RESPONSE TO REQUEST FOR ADDITIONAL INFORMATION

APR1400 Design Certification

RAI No.: 240-8318

SRP Section: 15.01.01-15.01.04 - Decrease in Feedwater Temperature, Increase in Feedwater Flow, Increase in Steam Flow, and Inadvertent Opening of a Steam Generator Relief or Safety Valve

Figure 1. SG steam flow rate vs. Time (IOSGADV+LOOP)

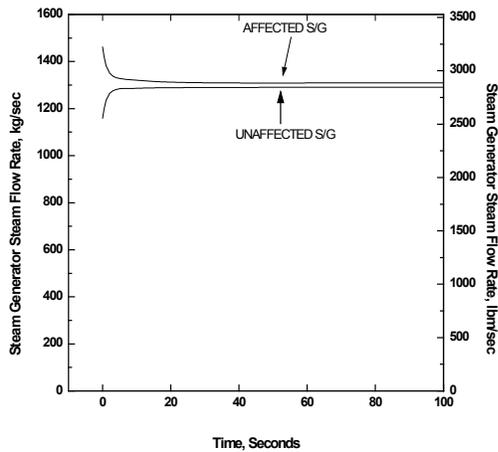
1. Figures 15.1.4-1.1 through 15.1.4-1.15 and Figures 15.1.4-2.1 through 15.1.4-2.15 of the DCD present the salient NSSS parameters for the Inadvertent Opening of a Steam Generator Atmospheric Dump Valve (IOSGADV) event. The abscissas in the figures begin at 0 seconds, which coincides with the time that the atmospheric dump valve is opened. Therefore, it is not possible to view the magnitude of the perturbation to the system resulting from the opening of the atmospheric dump valve (this is most clearly demonstrated in Figures 15.1.4-1.9 and 15.1.4-2.9). NRC staff requests the figures in DCD Section 15.1.4 be updated to present a brief null transient before the initiation of the event.

1. Figure 1 corresponding to Figure 15.1.4-1.9 shows a brief null transient before the initiation of the event. Also Figure 2 corresponding to Figure 15.1.4-2.9 shows a brief null transient before the initiation of the event. However, it is not practical to show a brief null transient before the initiation of the event, because all events are assumed to begin at 0 seconds. In addition, sections describing the sequence of events and system operation, and results provide sufficient information on the magnitude of the perturbation to the system resulting from the opening of the atmospheric dump valve.
